City of Canby

Staff Report File #: DR 20-02 / PAR 20-02 – Baker Center

HEARING DATE: August 10, 2020

STAFF REPORT DATE: July 31, 2020

MASTER SITE PLAN

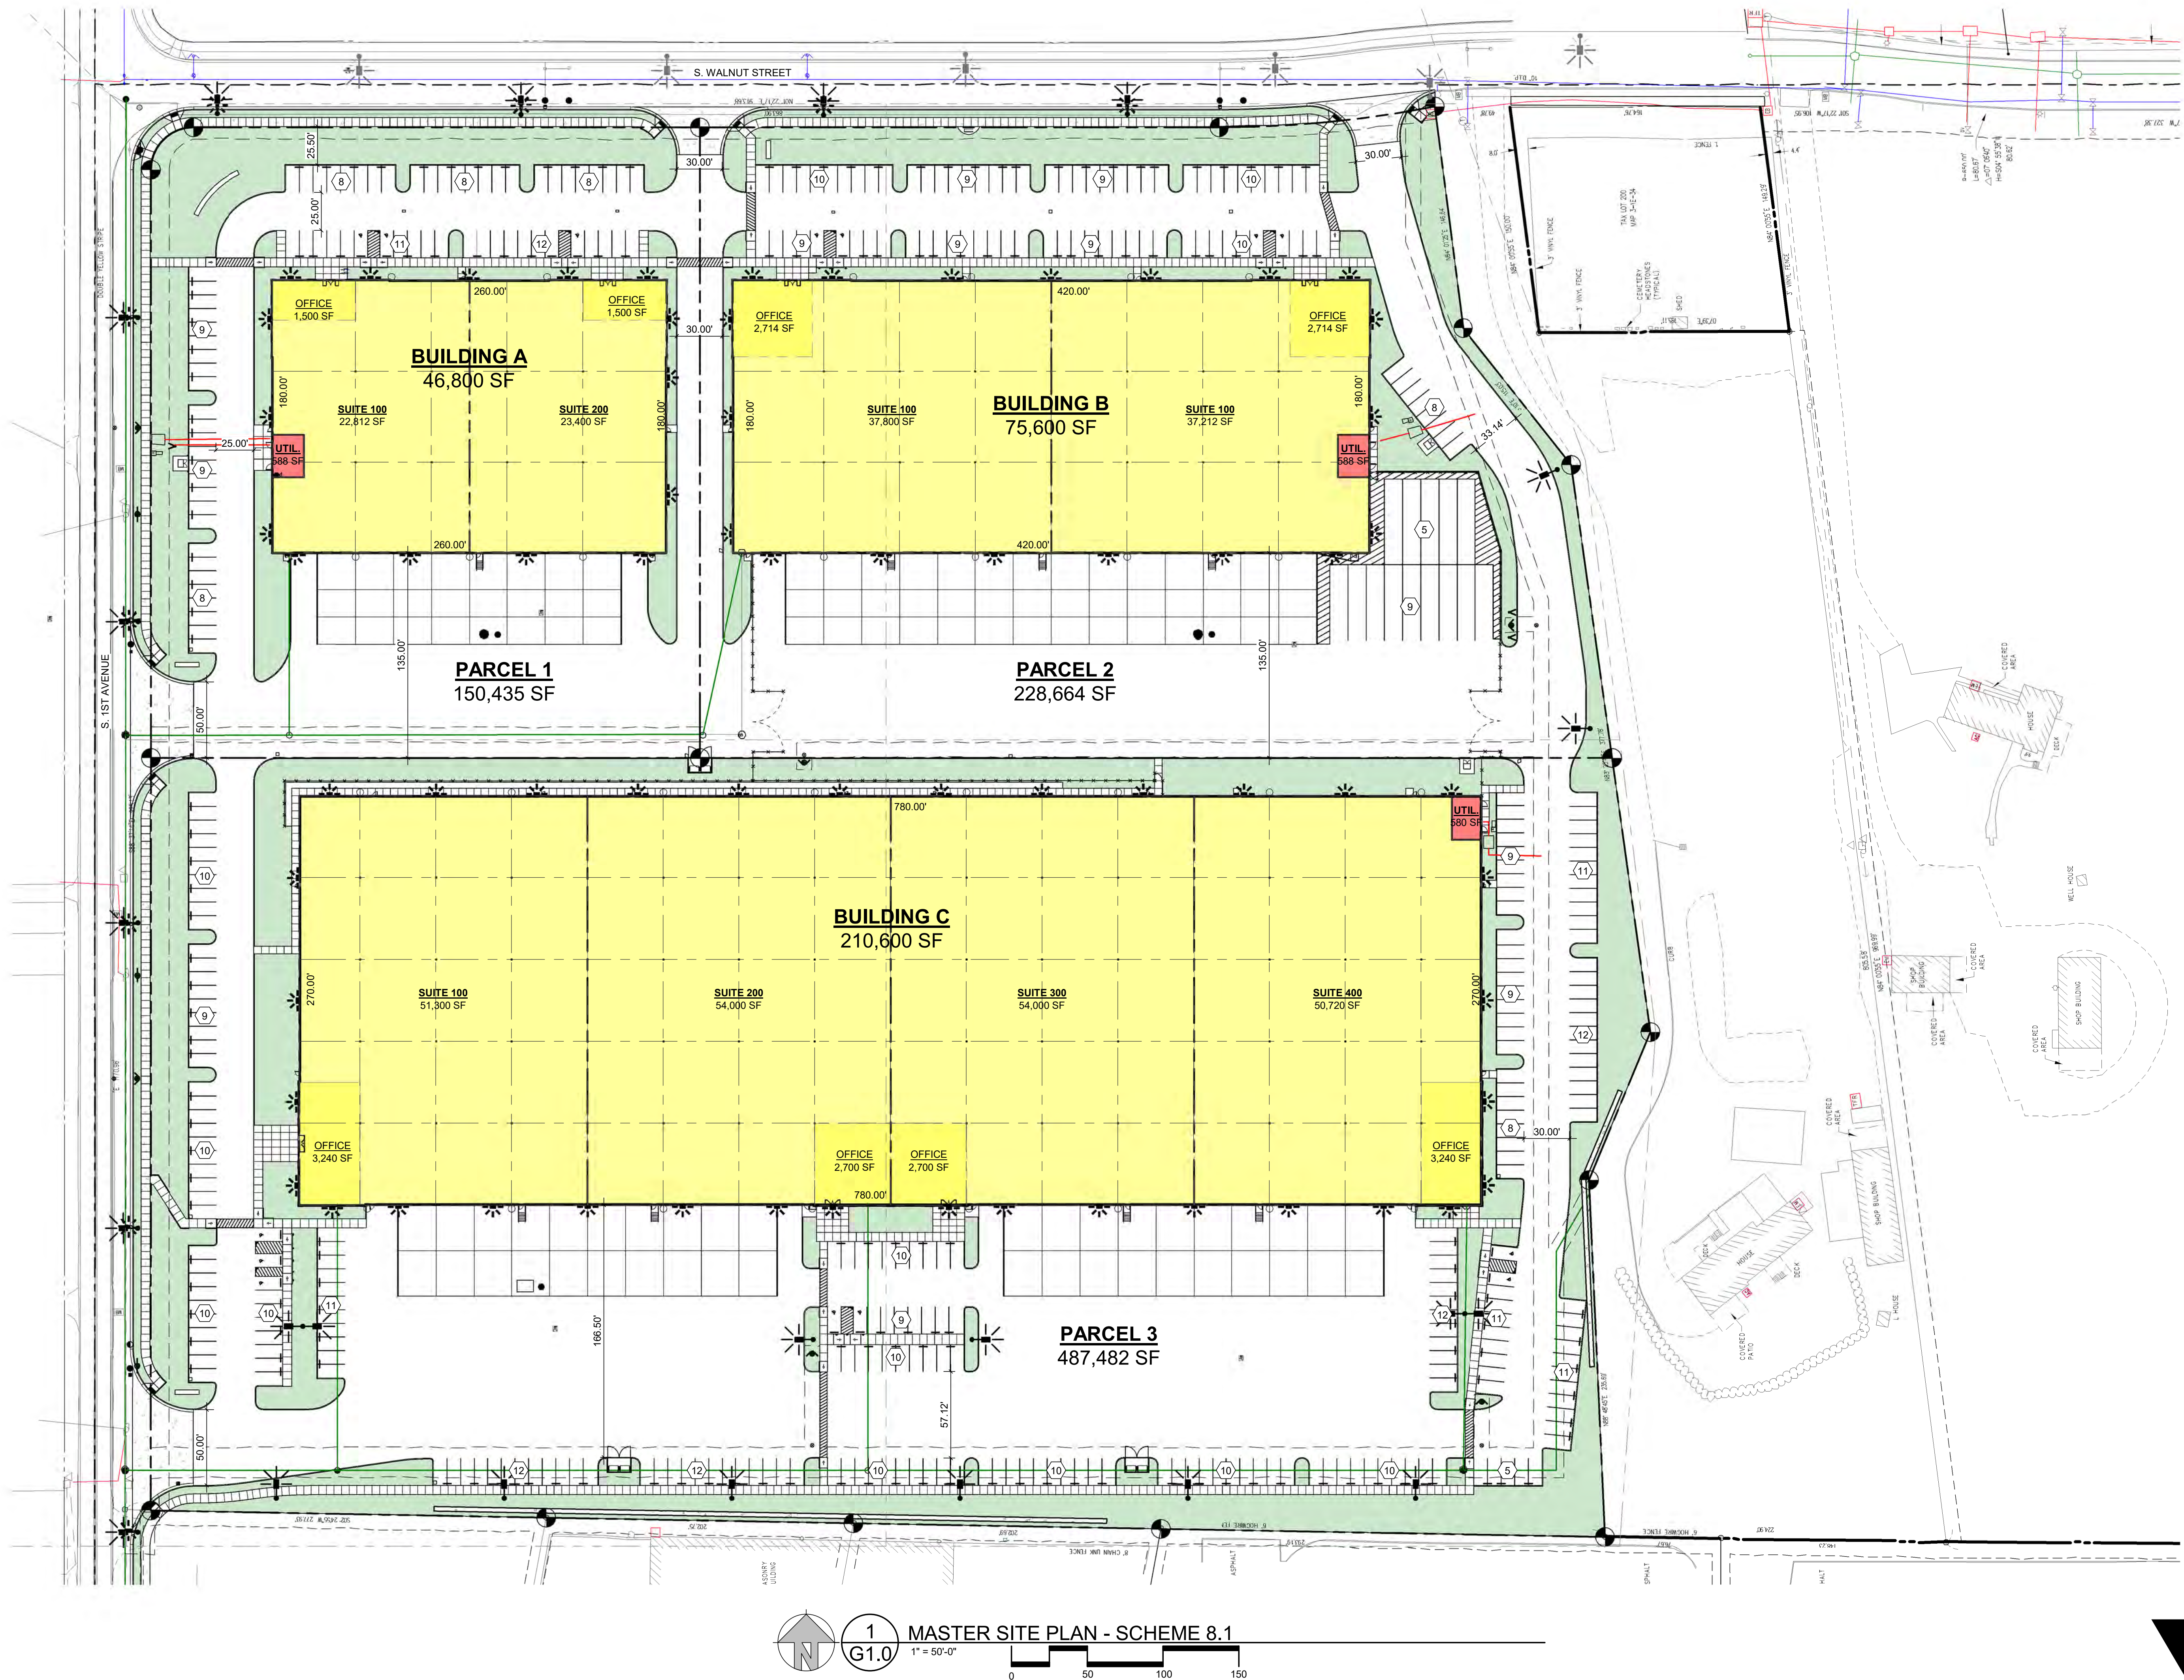
Submitted design drawings for the proposed project do not identify bicycle parking, provision of which is required by the Canby Municipal Code. Section V of this Staff Report includes a condition of approval requiring that the project design be modified to include bicycle parking as required.

Subsection 16.49.120 (E) requires all parking areas with more than 16 spaces shall include landscaping islands to "break up the parking area into rows of not more than 8 contiguous parking spaces." This requirement is not met by the proposed project, which includes rows containing 9 to 12 spaces. Section V of this Staff Report includes a condition of approval requiring that the project design be modified to comply with this standard.

As discussed on Page 5 of this Staff Report, the surface parking proposed for the project site will be required to be reconfigured in order to provide additional landscaped islands as required by the Canby Municipal Code. This may affect the project's overall parking count. However, because the project design currently has substantially more parking than required, this reconfiguration is not expected to result in an overall deficiency in parking. Final site plans for the proposed project shall demonstrate this compliance.

The intersection of the two aforementioned streets is the current terminus of S Walnut Street, which is planned to be extended from that location to Highway 99E. Although the future extension of S Walnut Street (and a turnabout to aid S Walnut Street's transition from a local street section to an industrial collector street) is a standalone project not contingent on the proposed project, some right-of-way dedication at the intersection of SE 1st and S Walnut Street will be required. Section V of this Staff Report identifies a condition of approval related to this requirement, which likely requires modifications to the northeastern corner of the proposed project's final design.

31. Consistent with Subsection 16.10.100, *Bicycle Parking*, of the Municipal Code, the proposed project shall be modified to provide bicycle parking within 50 feet of the main entrance of each building. Prior to site plan approval, the project applicant shall submit a final site plan demonstrating that the location and design of proposed bicycle parking conforms to the aforementioned code section. (R. Potter)

32. Consistent with Subsection 16.49.120, *Parking Lot Landscaping Standards*, the proposed surface parking shall be redesigned to “break up the parking area into rows of not more than 8 contiguous spaces.” Prior to site plan approval, the applicant shall submit to the City a revised site plan demonstrating compliance with this condition, along with revised landscaping calculations reflecting the change in site design/lot coverage. (R. Potter)

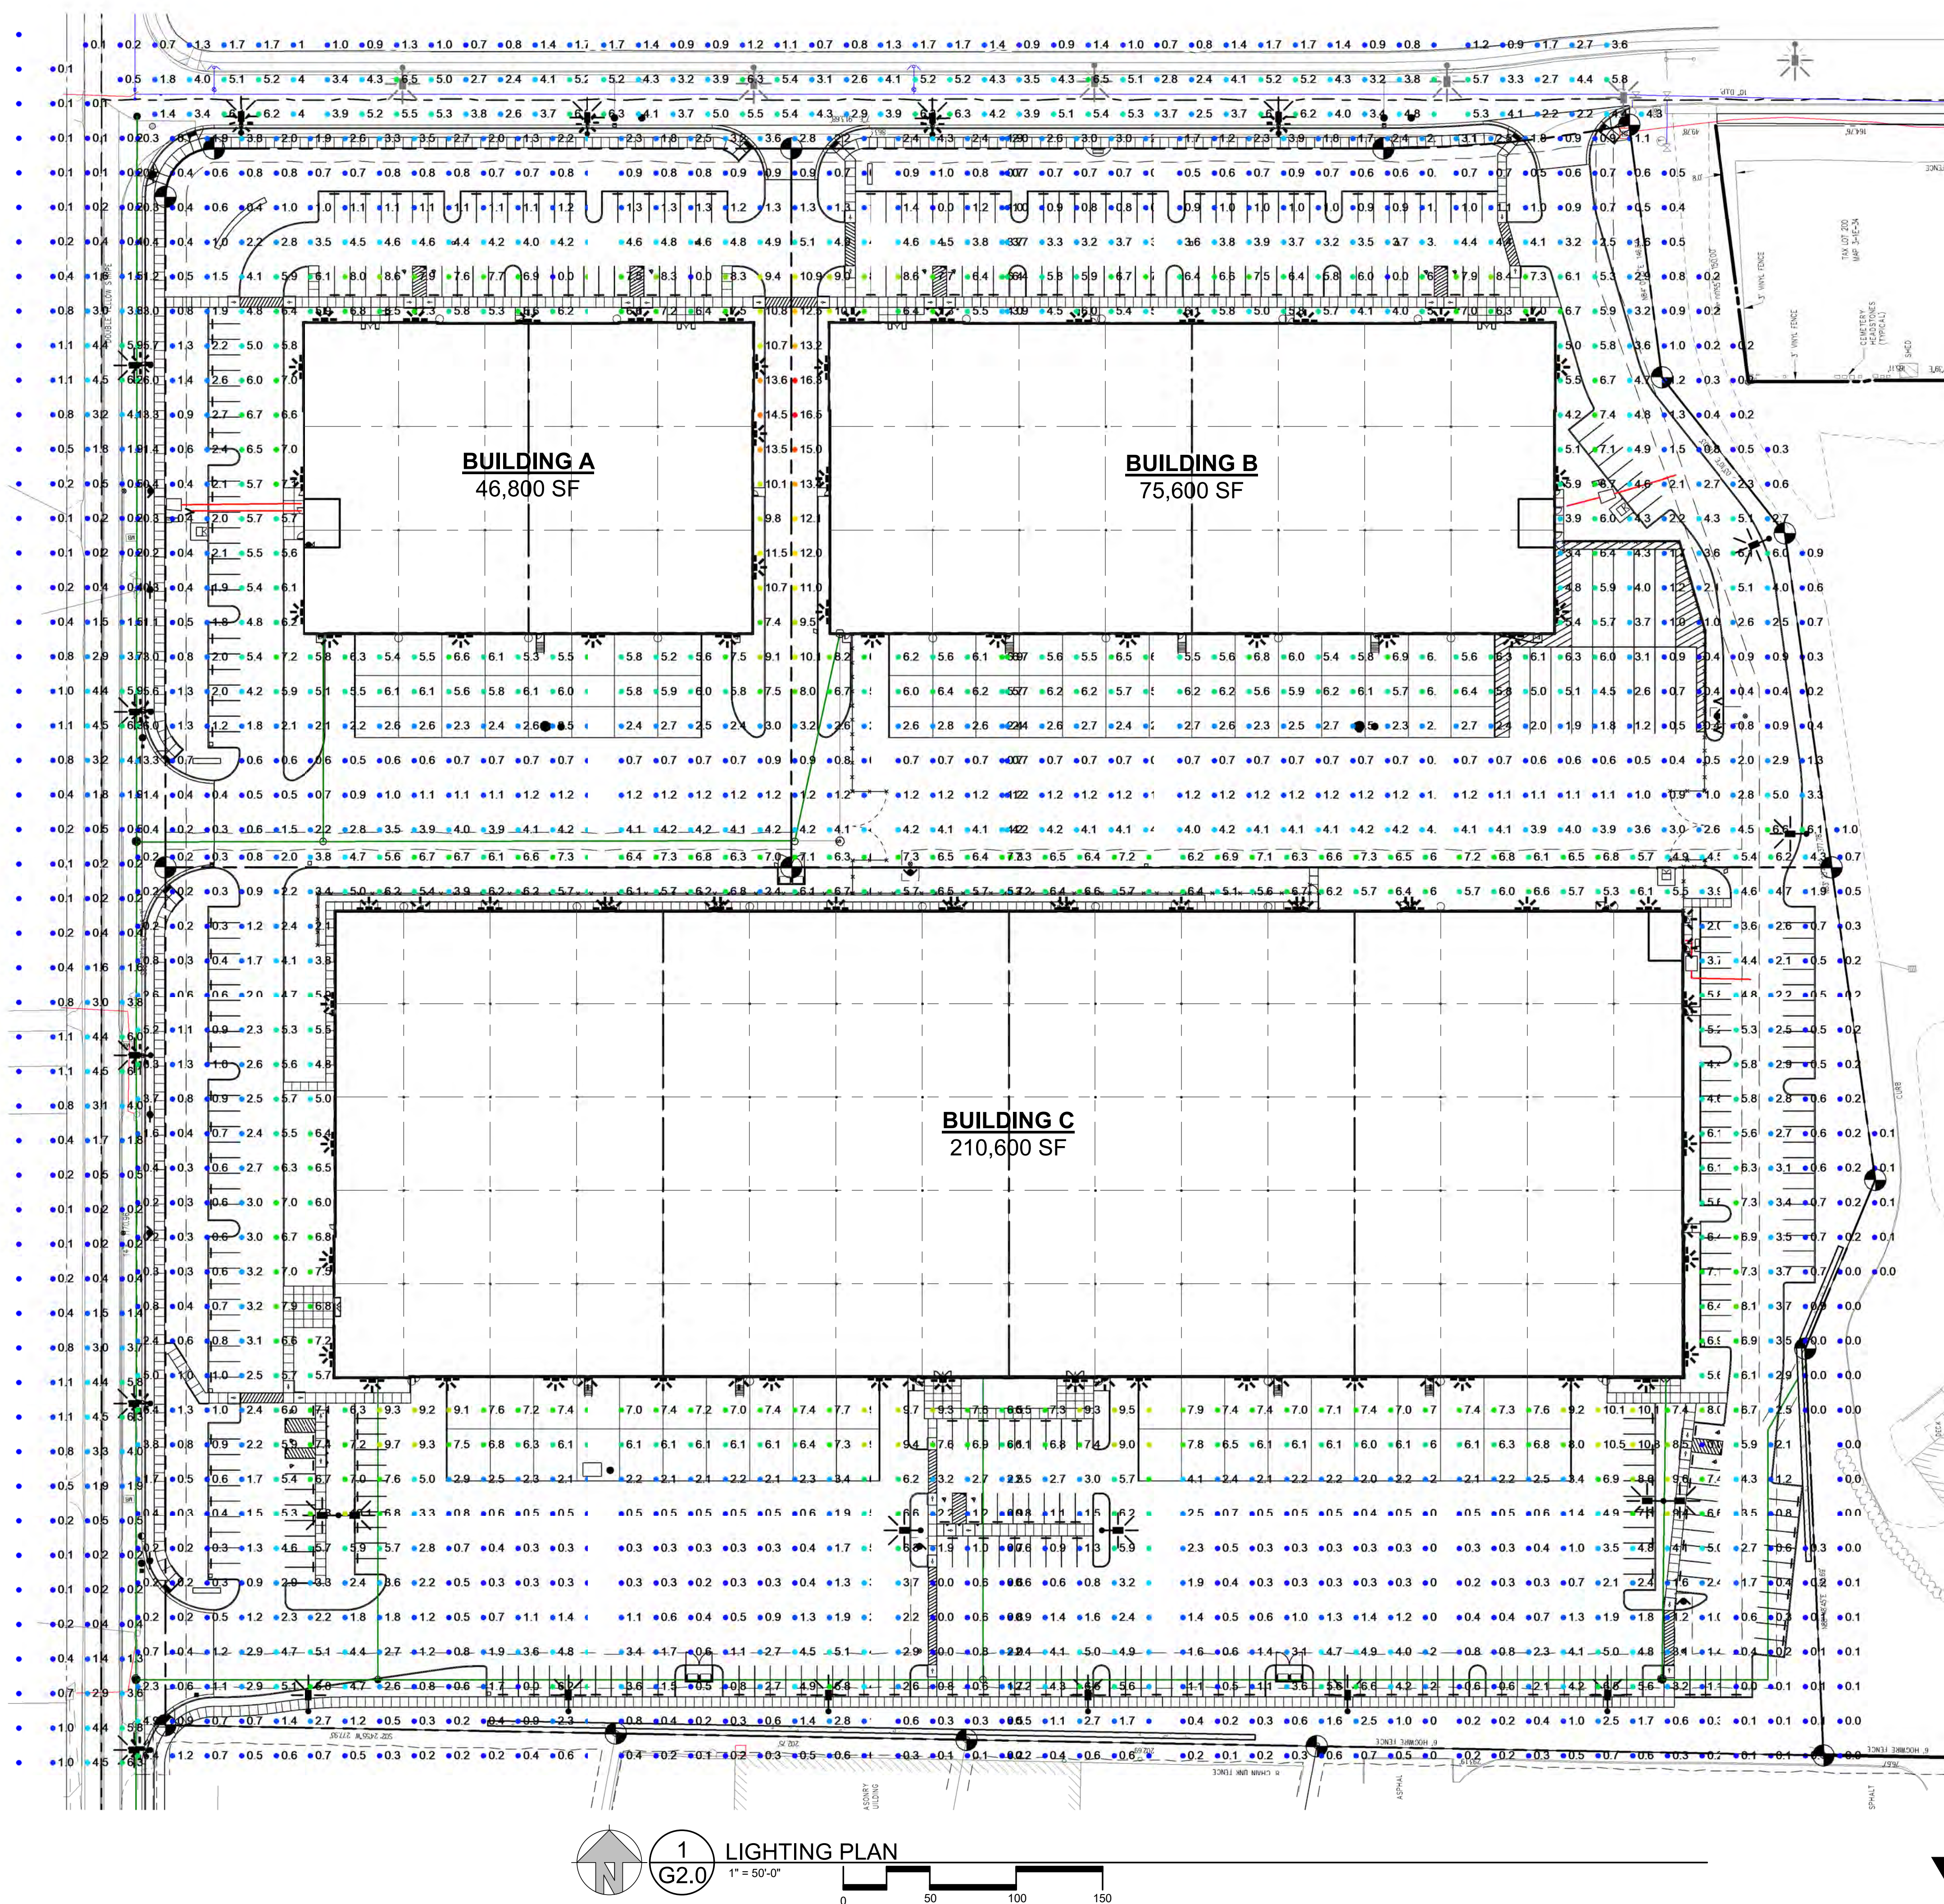
As currently proposed, Staff does not anticipate a lack of compliance with City lighting standards. The provided photometric plan demonstrates that light overspill onto surrounding properties is minimal (between 0 and 1 foot candles). Furthermore,

landscaping has been designed to minimize glare from headlights onto the site from surrounding streets and vice-versa. However, prior to site plan approval, the project applicant will be required to submit a lighting plan to the City of Canby consistent with Section 16.43.110 of the Municipal Code. Section V of this Staff Report includes a condition of approval requiring that a more comprehensive lighting plan to be submitted showing how the proposed light fixtures and luminaires meet the requirements (e.g., shielding) of this section.

33. Prior to site plan approval, a lighting plan shall be submitted to the City consistent with Chapter 16.43, *Outdoor Lighting Standards*, of the Municipal Code. This shall include an exhibit(s) demonstrating that the proposed light fixtures would be shielded and that light generated would not exceed the maximum lumens identified in Table 16.43.070 of the Canby Municipal Code. (R. Potter)
